Sept. 28, 2017

ADMINISTRATIVE HEARING

STAFF REPORT

PROJECT: Elizabeth Subdivision, PDP160046

HALF LOT LINE @ CENTER OF BACK PORTION

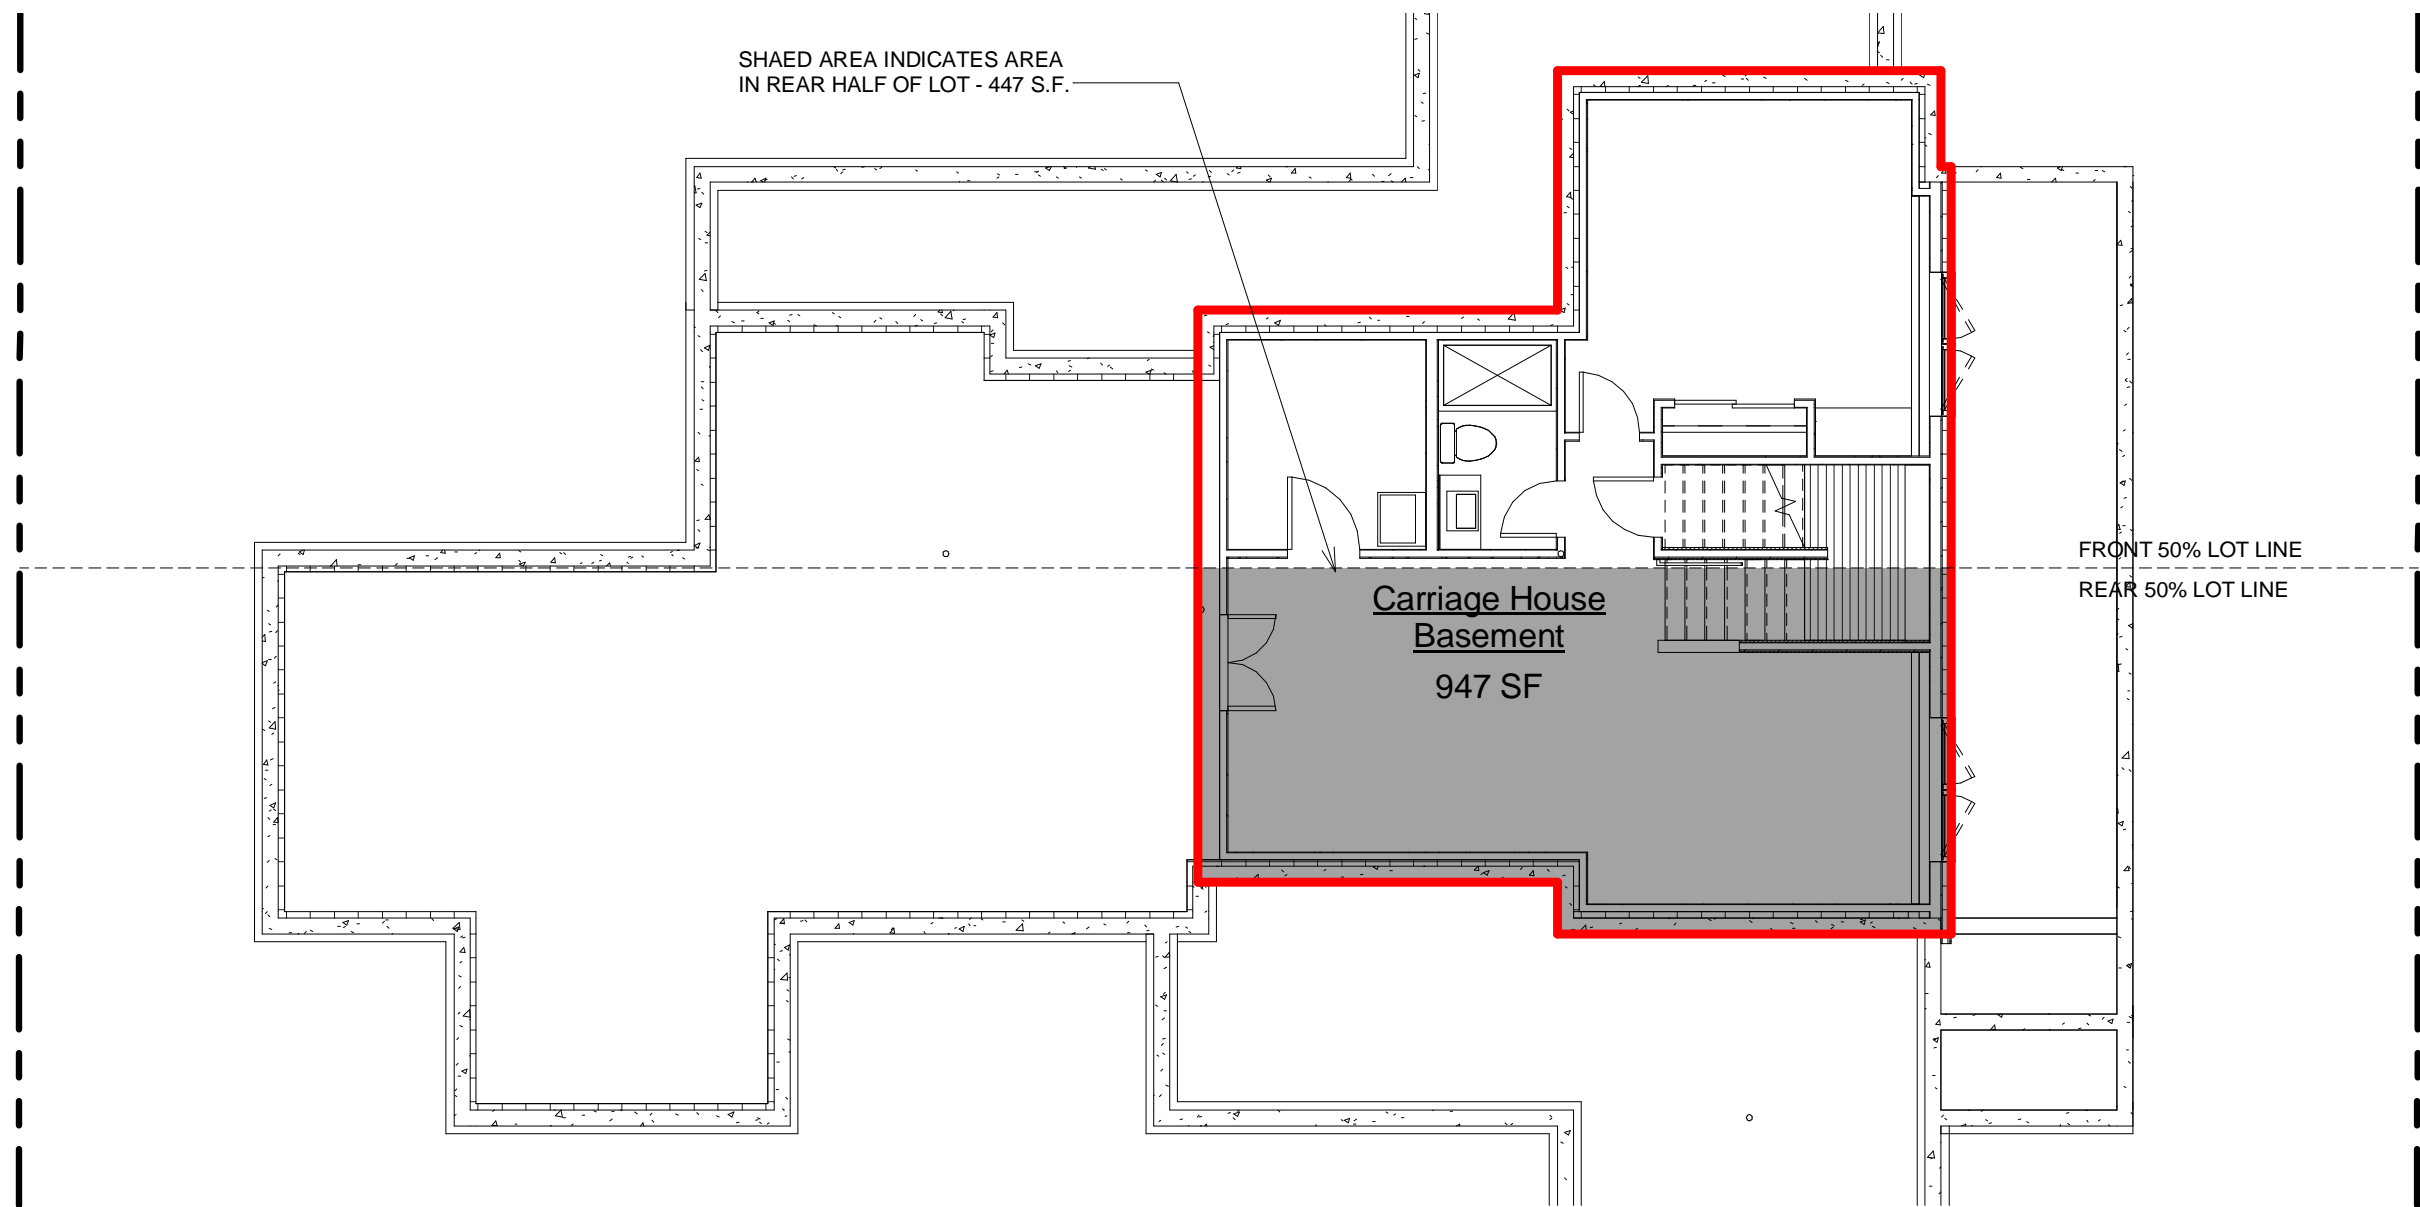
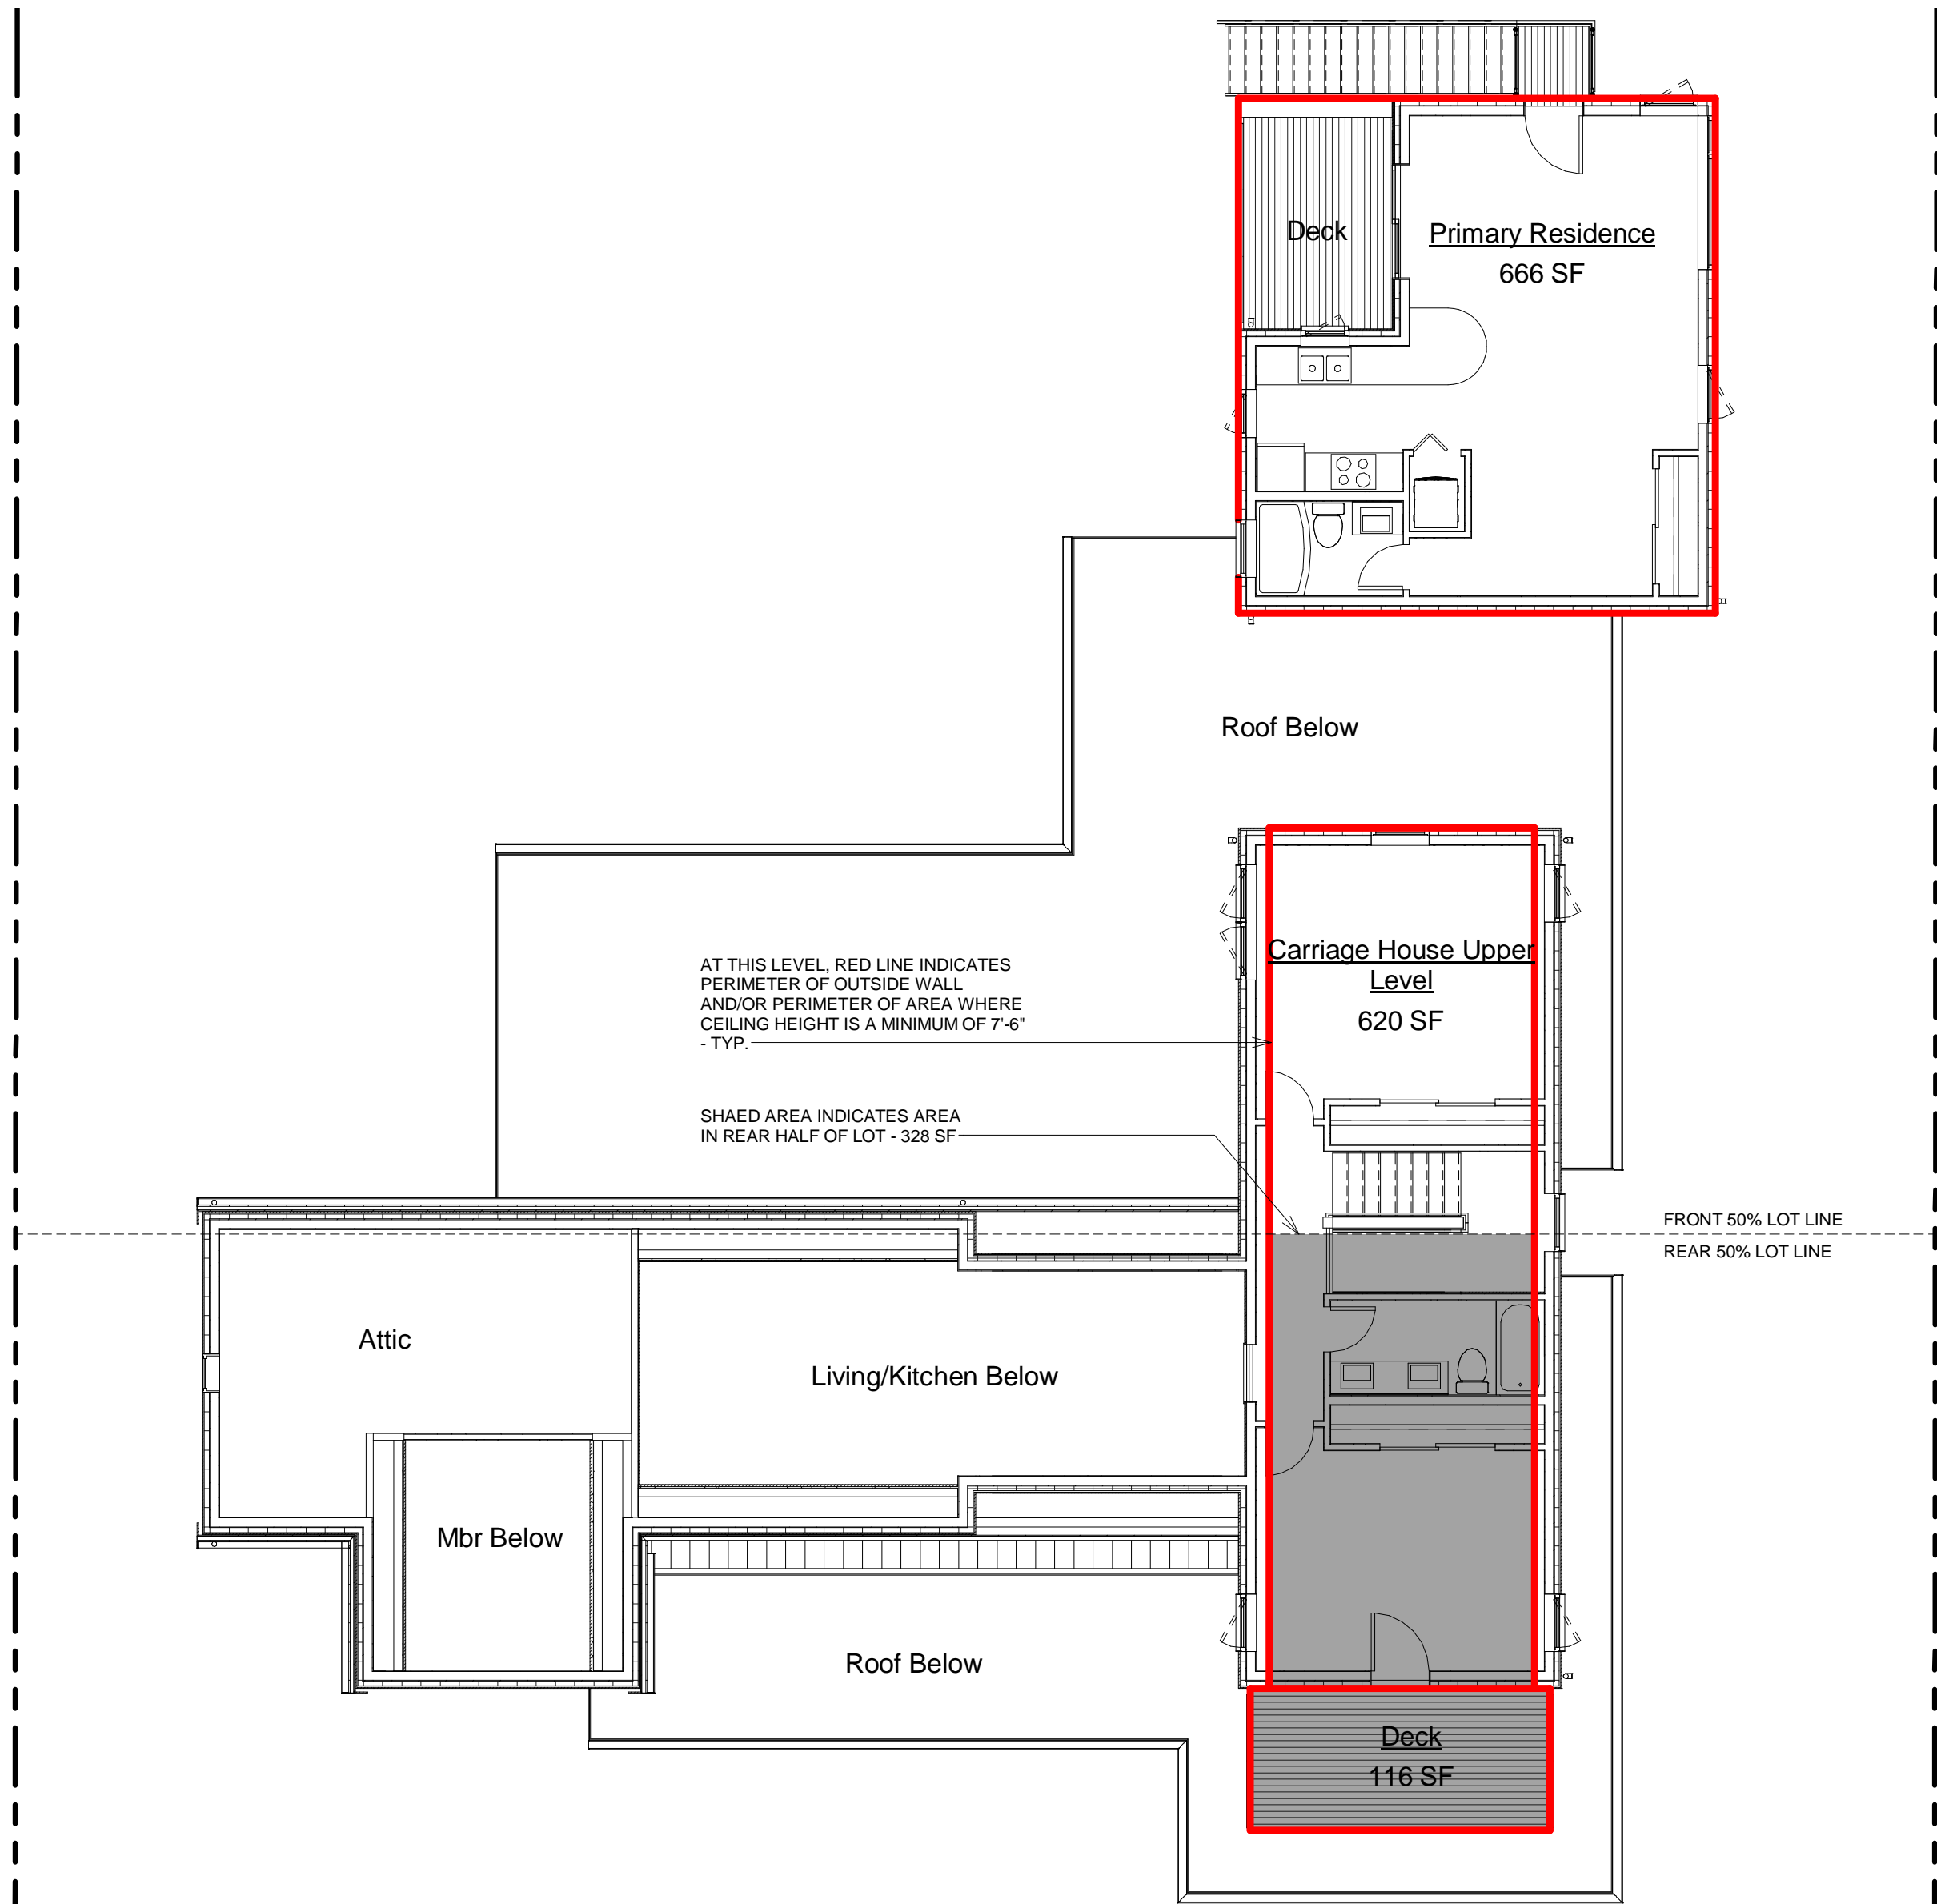
- *Flagpole creating skewed mid lot line: If the mid lot line did have to take into account the flagpole portion of the lot then the mid lot line would move further south. As the plan is shown with the carriage house in the rear and primary residence in front this would result in only 140 sf over the maximum allowed amount. Please see attached Floor Area Diagram – Theoretical A-3.*

Staff finds that the request for a Modification of Standard to section 4.7(D)(3) is justified by the applicable standards in 2.8.2(H)(1).
